ONONDAGA COUNTY DEPARTMENT OF PUBLIC WORKS
 DIVISION OF DRAINAGE AND SANITATION
METROPOLITAN SYRACUSE SEWAGE TREATMENT PLANT
 MECHANICAL
DIGESTER CONTROL HSE. BASEMENT PLAN

ONONDAGA COUNTY DEPARTMENT OF PUBLIC WORKS
 DIVISION OF DRAINAGE AND SANITATION
METROPOLITAN SYRACUSE SEWAGE TREATMENT PLANT
 MECHANICAL
DIGESTER CONTROL HSE. FIRST FLOOR PLAN

DIGESTER CONTROL HSE. SECOND FLOOR PLAN

PLAN OF EXISTING DIGESTER CONTROL HOUSE AT ELEV 372.50'
 scale 1/4" = 1'-0"

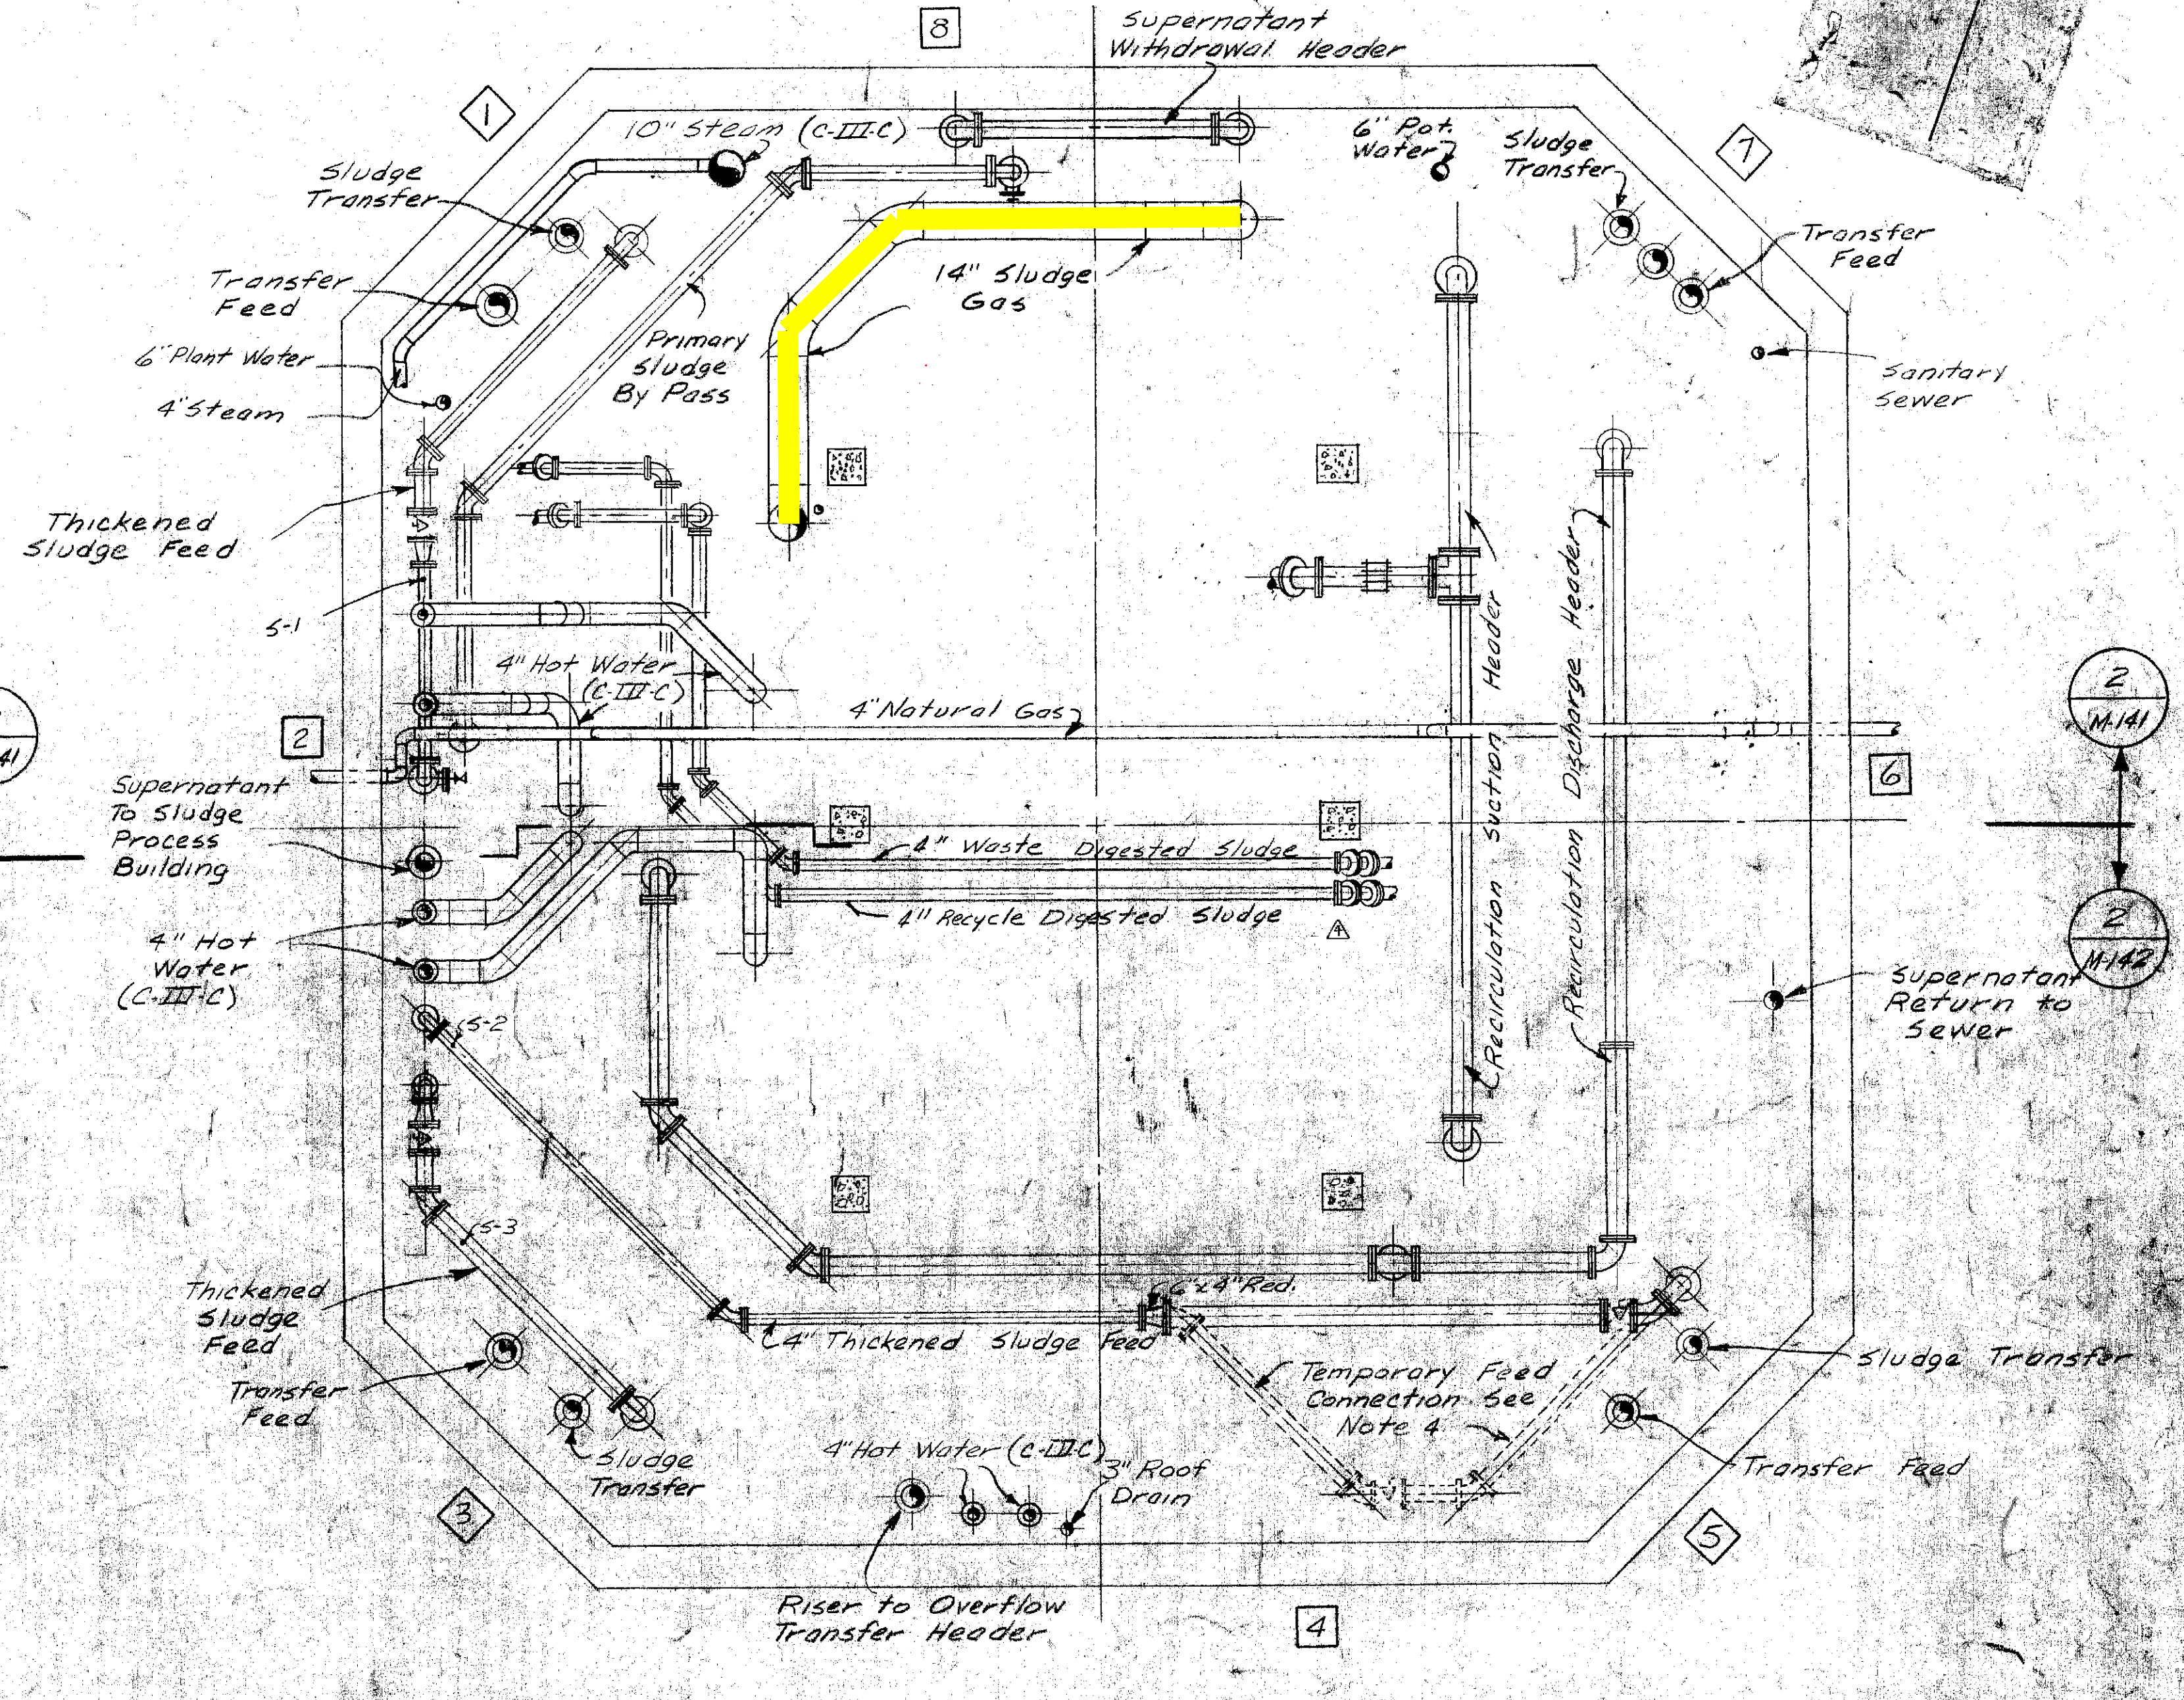
Need to be Replaced:
 Existing Stainless Steel:

EXISTING PLAN OF DIGESTER CONTROL HOUSE AT ELEV 383.50'
 scale 1/4" = 1'-0"

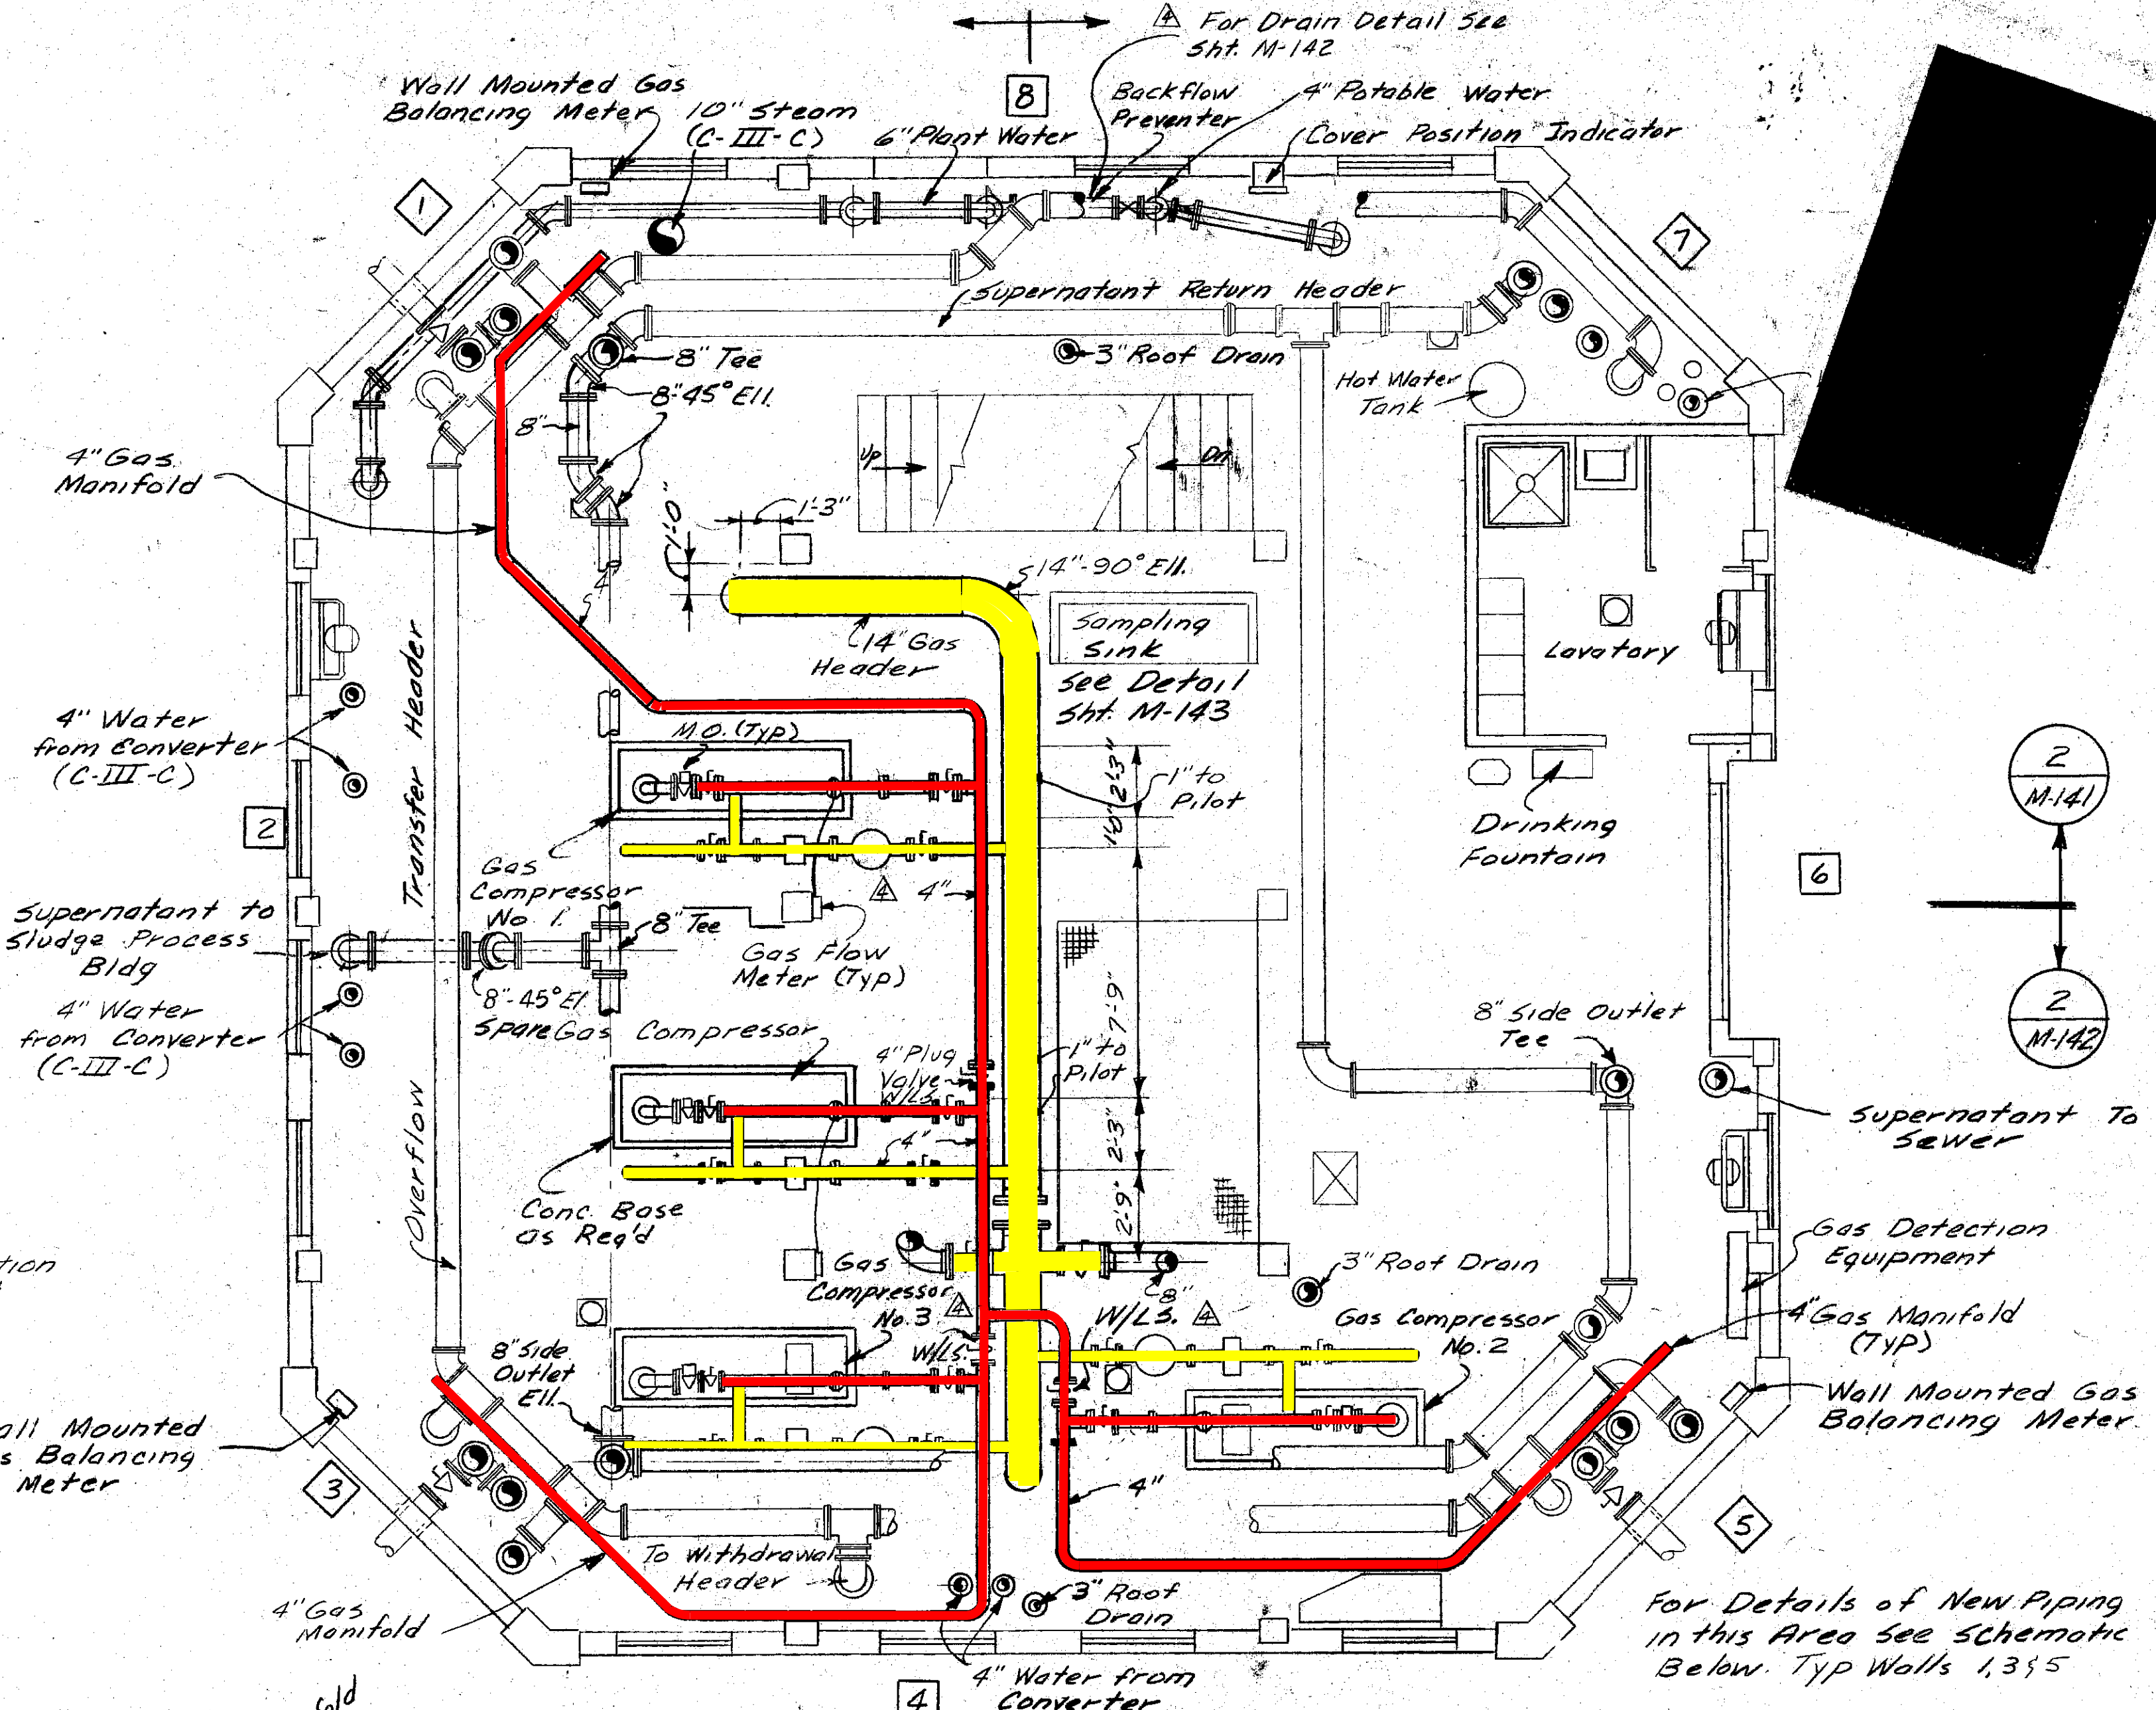
Need to be Replaced:
 Existing Stainless Steel:

EXISTING PLAN OF DIGESTER CONTROL HOUSE AT ELEV 393.50'
 scale 1/4" = 1'-0"

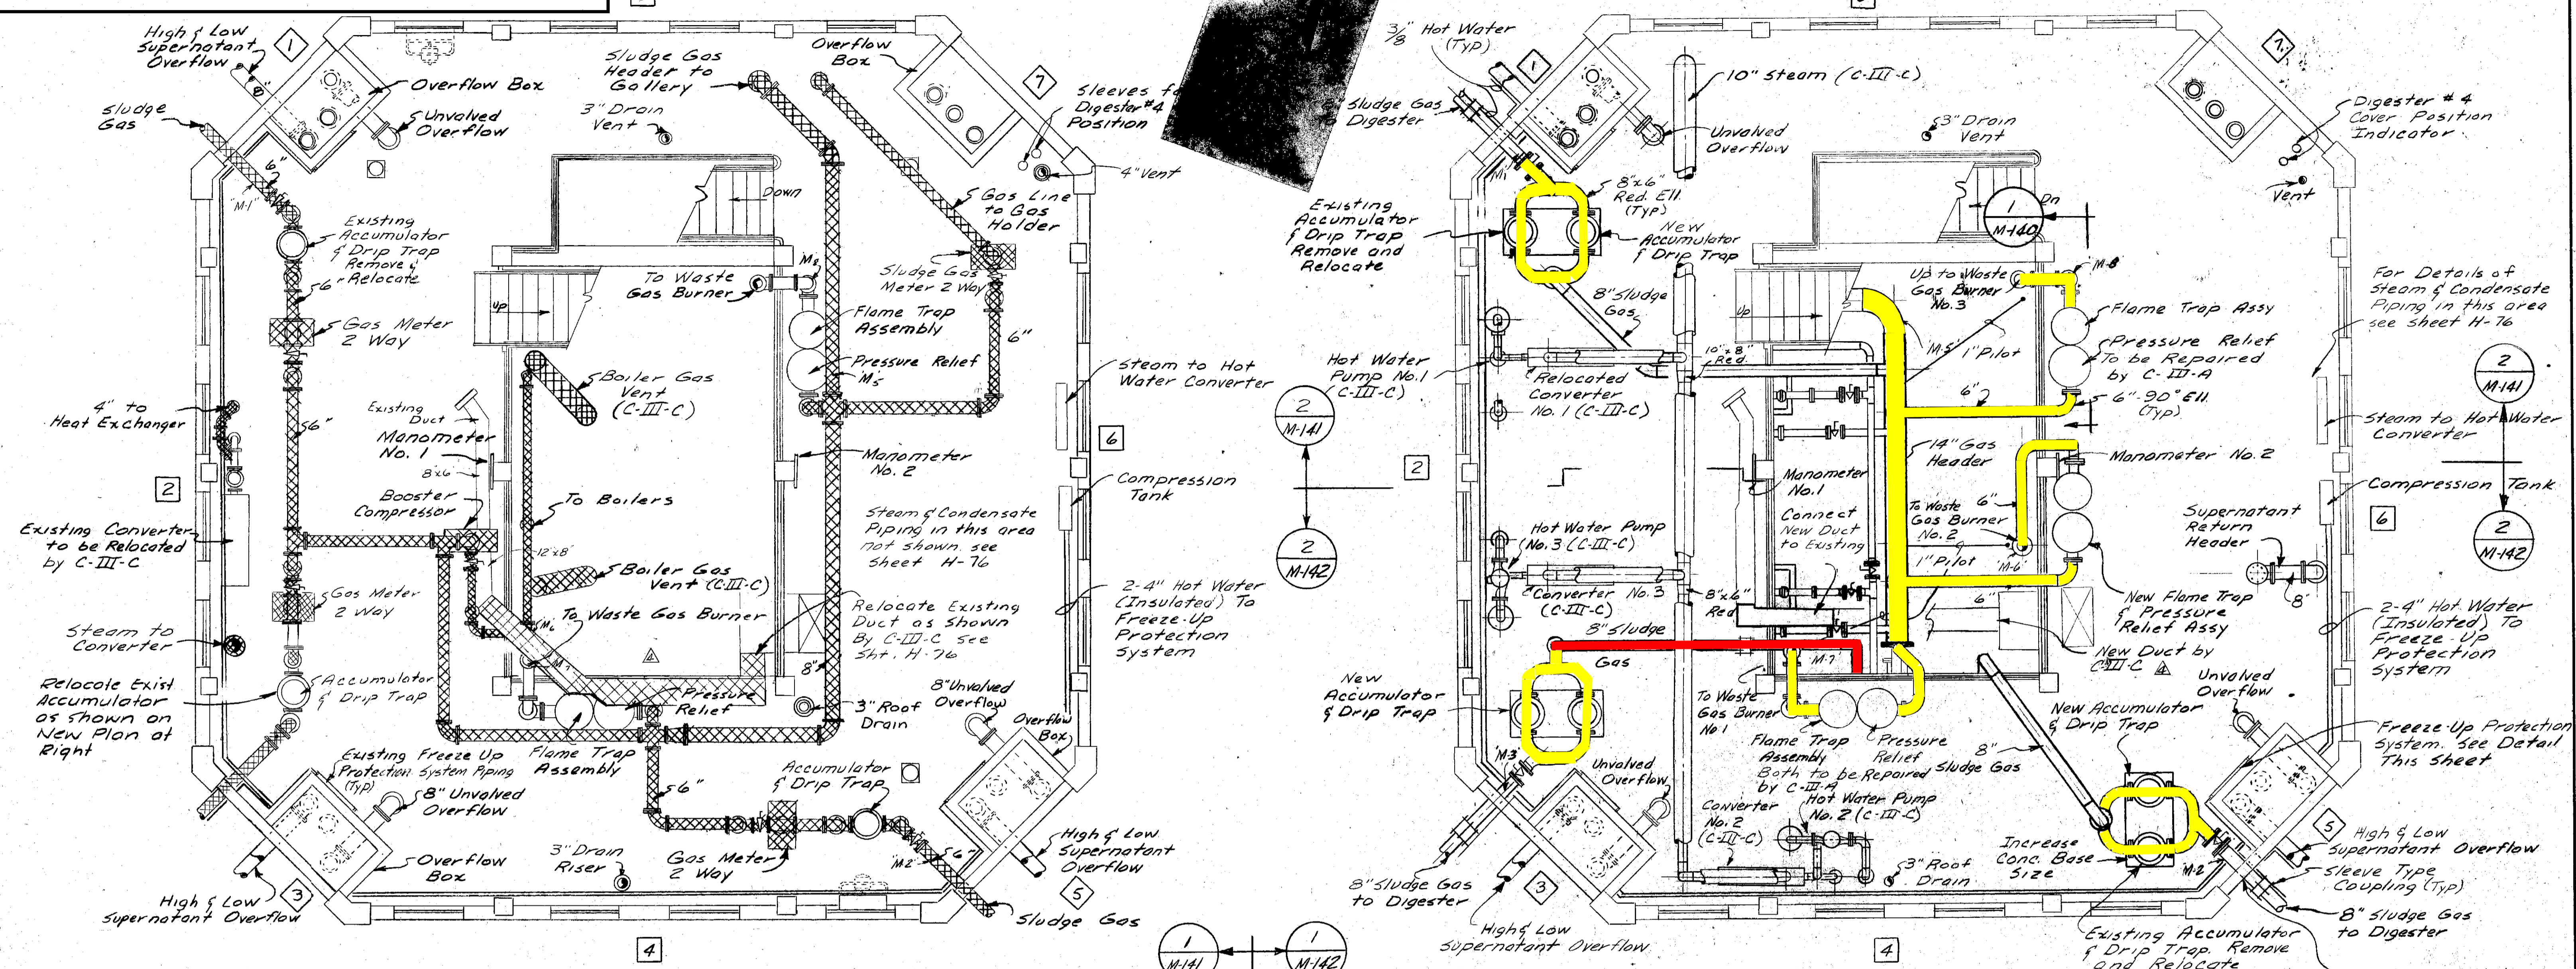
Need to be Replaced:
 Existing Stainless Steel:
